License No. 06-00217-06

Subject: **License Amendment Request**

**COMBUSTION ENGINEERING SITE
Windsor, CT.**

**Application for Amendment
US NRC License Number 06-00217-06
Docket Number 030-03754**

Figure 7.1-1 provides an organization chart depicting the organizational relationships of personnel related to radiation safety for this license application.

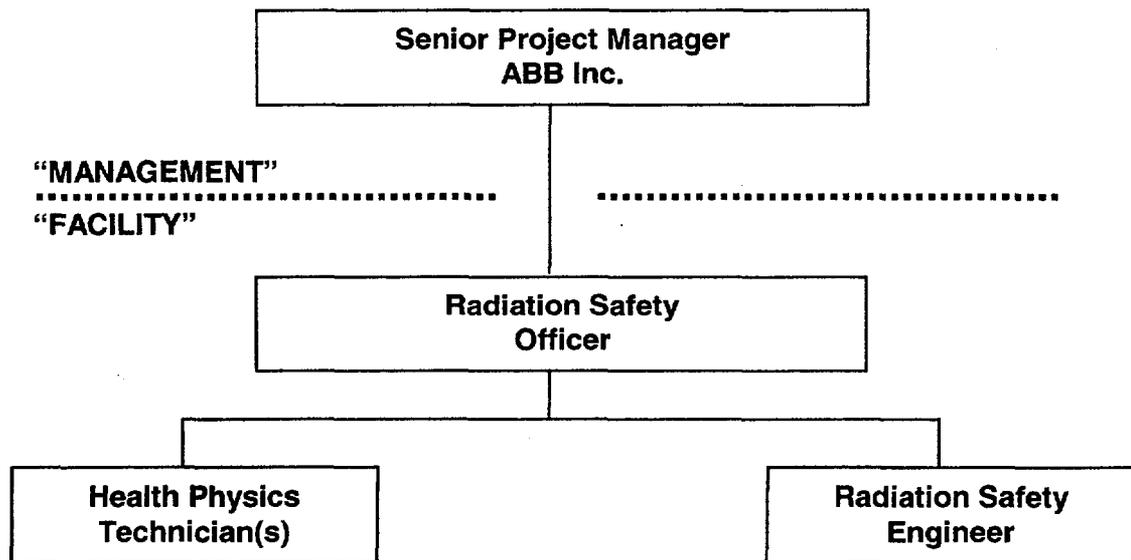
- Page 4, Section 7.1:
 - Change section title to "Management" to more accurately reflect content of the section.
 - The organization chart is modified to be consistent with NRC License No. SNM-1067 and reflect contemporary site conditions.

- Change "CORPORATE" in organization chart to "MANAGEMENT" to more closely align chart terminology with that of text in the section.
 - Under Note 1, add RSO as a part-time function, since all facilities under the Decommissioning Plan have been removed, thus eliminating virtually all authorized work with licensed material. FUSRAP areas and buildings will remain until the U.S. Army Corps of Engineers authorizes removal action.

Figure 9-1

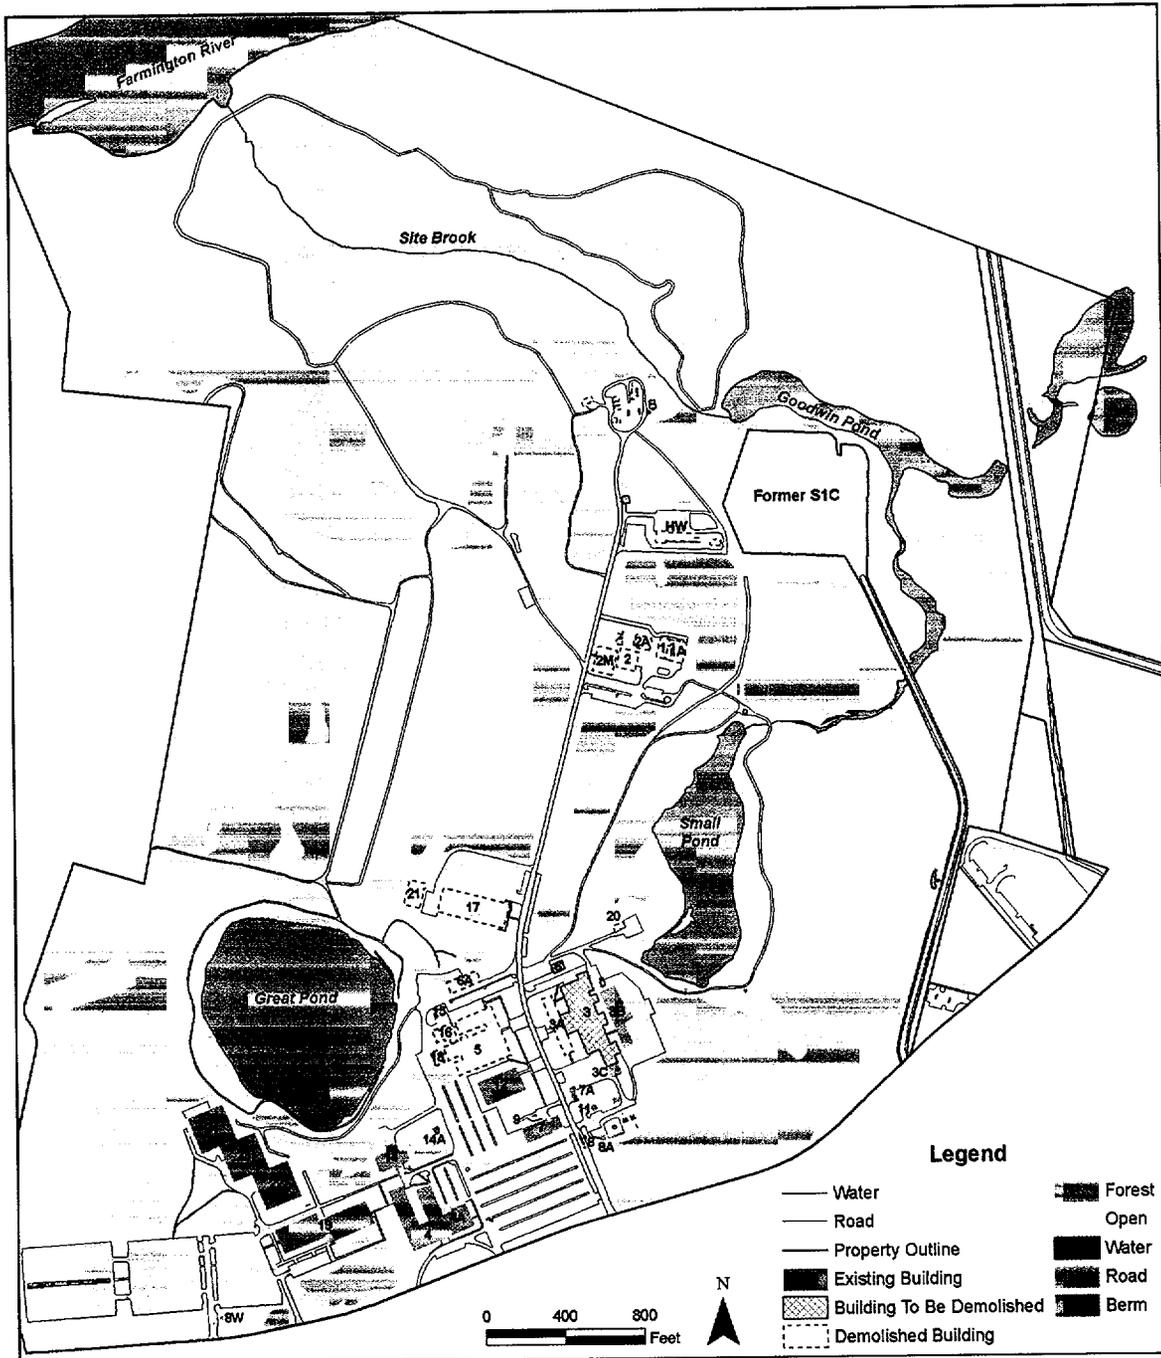
- Page 13, Figure 9.1: The CE Site Plan has been updated and revised to depict removed buildings.
- Page 14, Section 10.1: In paragraph two, the reference to Regulatory Guide 1.86 (1974) in the second sentence is changed to reflect a more contemporary version of the Guide, dated April 1993 and be consistent with NRC License SNM-1067.
